APPLICATION FOR EXCHANGE OF WATER

61-353 / Exchange # 79610

Re: Water Right Exchanges (#79609, 79610, 79611, 79612), Additional Information Request

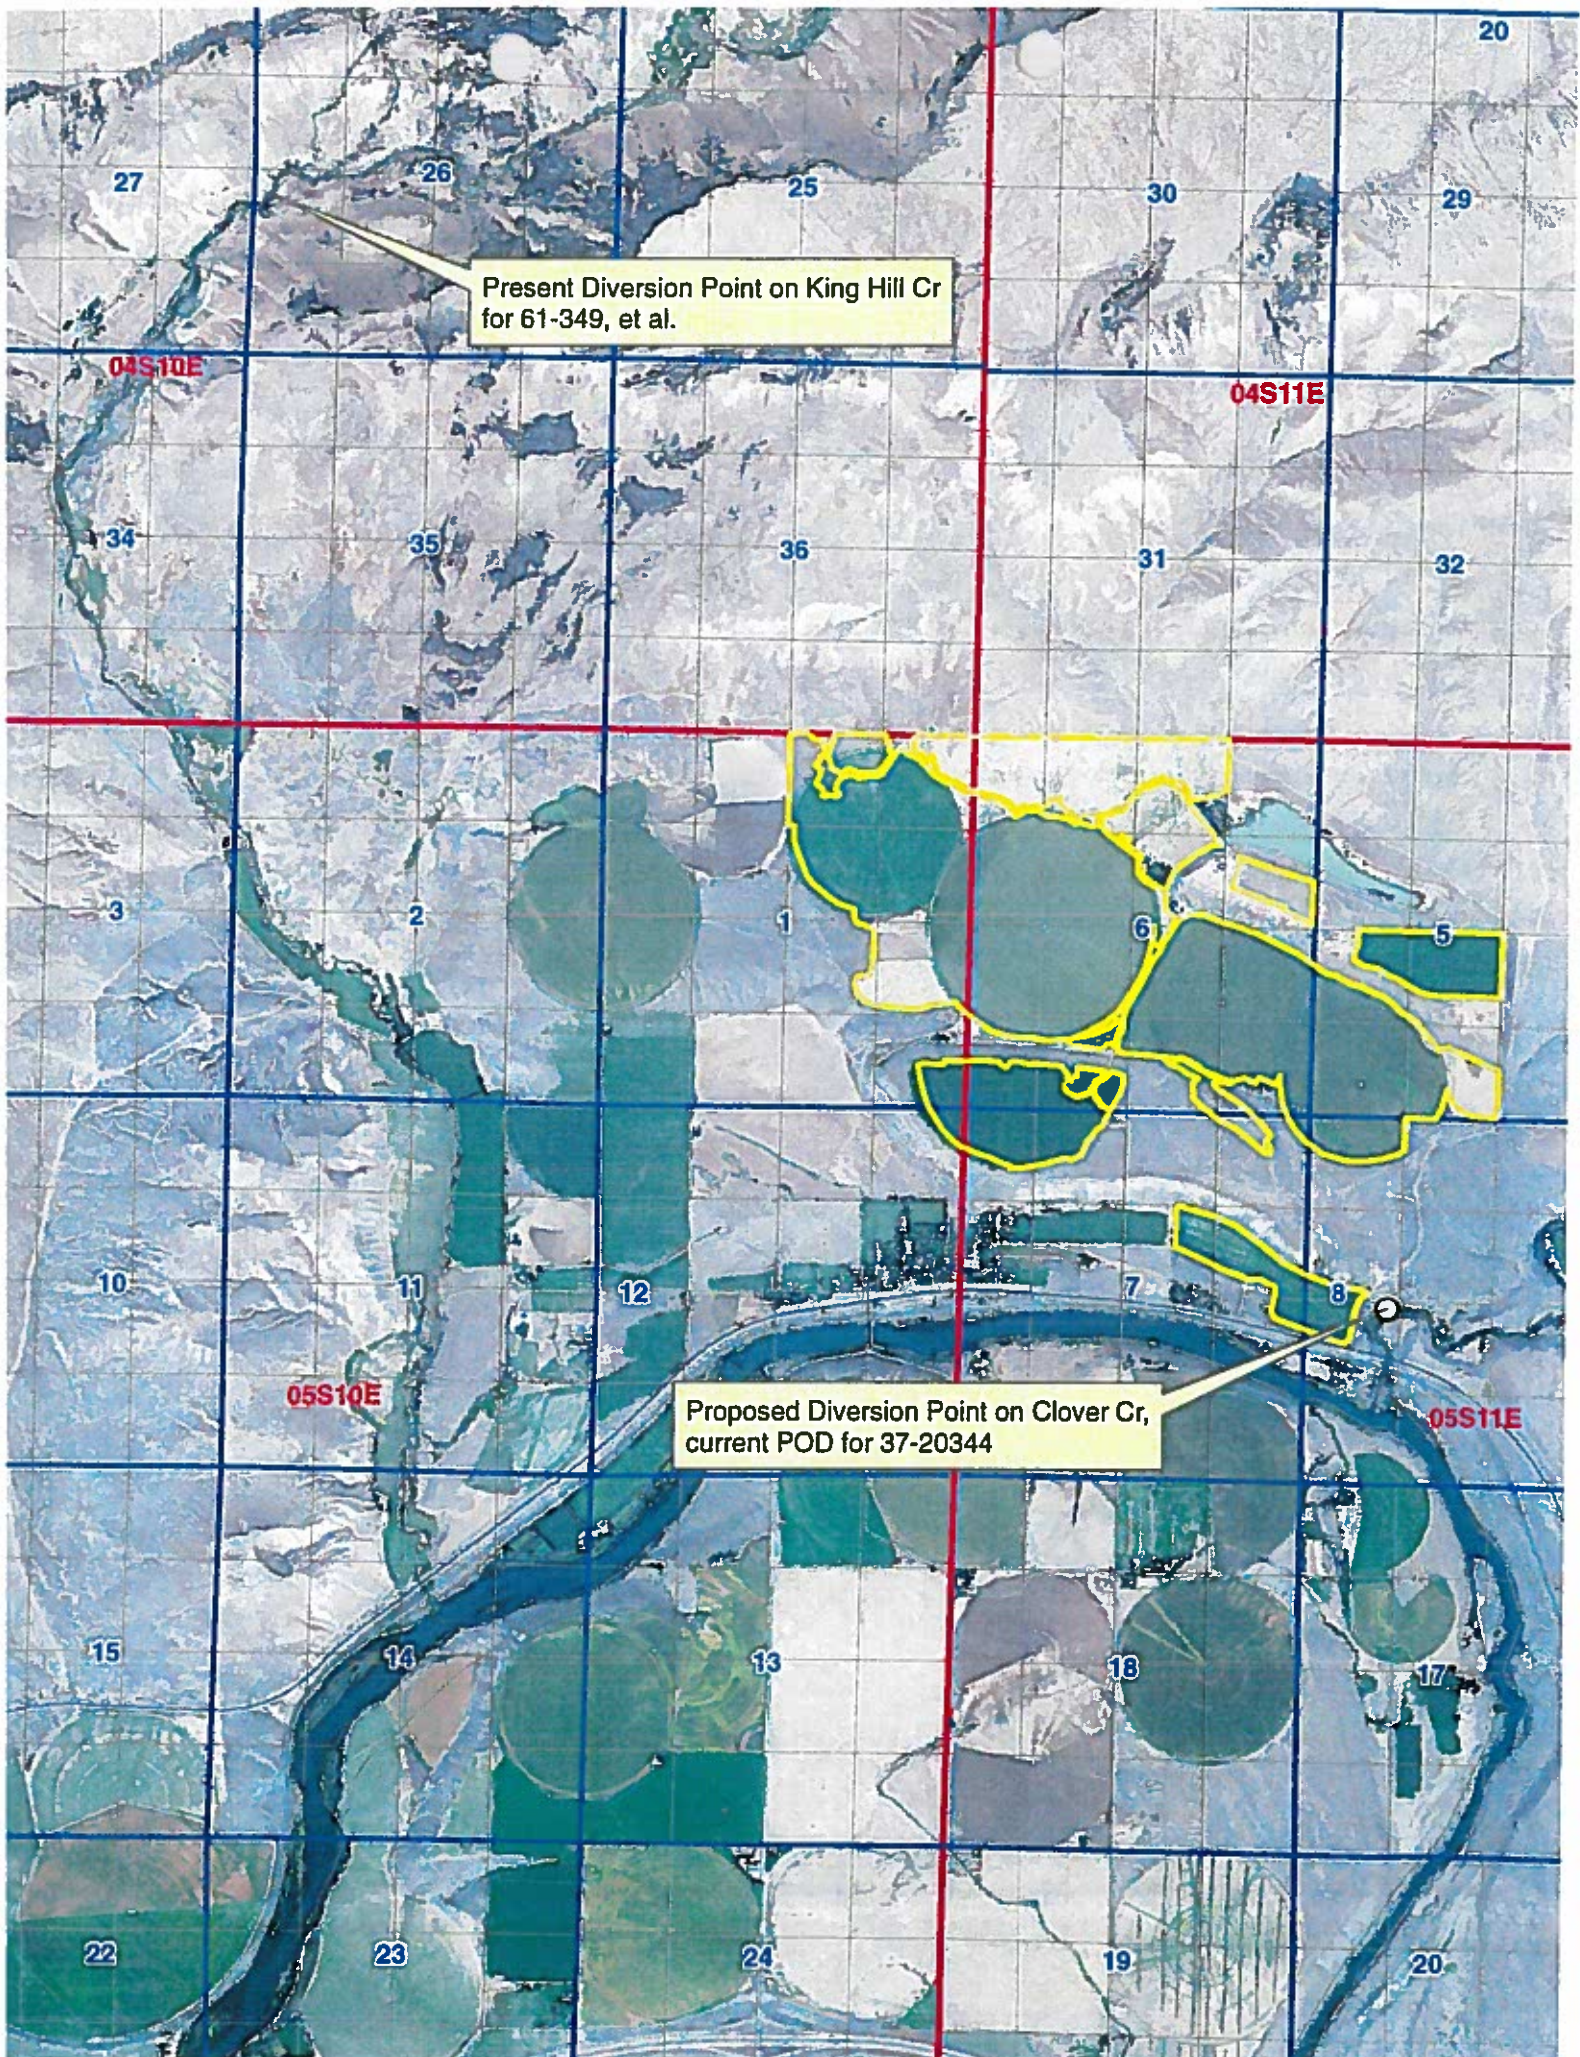
Pitchfork Ranch has proposed exchanges for 4 water rights diverted from King Hill Cr (rts 61-349, etc). The proposal is to then divert the rights from Clover Cr in Basin 37 at a point that already exists. The attached map portrays the circumstances.

There are some junior rights downstream from the present Pitchfork Ranch diversions. King Hill Cr has historically been a watermaster district, 61F, do either one of you know if it is active and, if so, then who would I be in touch with?

Corbin, as Basin 02 water Master, do you perceive of potential injury and/or recommend conditions? It would appear that a condition would be needed to limit diversion from Clover Cr to those priorities and flow rates that water is available from King Hill Cr. However, if there is no watermaster then how could it be regulated? Would Pitchfork need to measure water discharged to the Snake River from King Hill Cr (or at least measure below the junior downstream diversion) and limit exchange to that rate of flow? Do we have a capability to have Pitchfork self report flow rates and diversions? If the proposal is not administrable, then can/should we approve it?

If we are going to approve it then Southern Region is contemplating making the rights subordinate to all rights in Clover Cr. However, there isn't a watermaster on Clover Cr so we are back to the regulatory question.

I am in the same boat as Angie and Steve. I anticipate that this diversion is already occurring and without any active coordination between the two (unregulated) tributaries an impact to minimum stream flows on the Snake will occur. The King Hill Crk rights are basin 61 rights and moving this right into basin 37 will be an enlargement of what little water is available during the summer on Clover Creek that ultimately would end up in the Snake. I think your thoughts of what remaining water is in King Hill Crk at the confluence of the Snake is likely return flows from KHID.

I am not in support of exchanges in general but this one in my opinion should not be allowed due to the potential burden of other right holders out of the Snake River to support expansion of little to no water available in Clover Creek. This one will be more burdensome on actively regulating what is occurring and currently the WD02 watermaster would have no means of compensation to help administer this exchange.
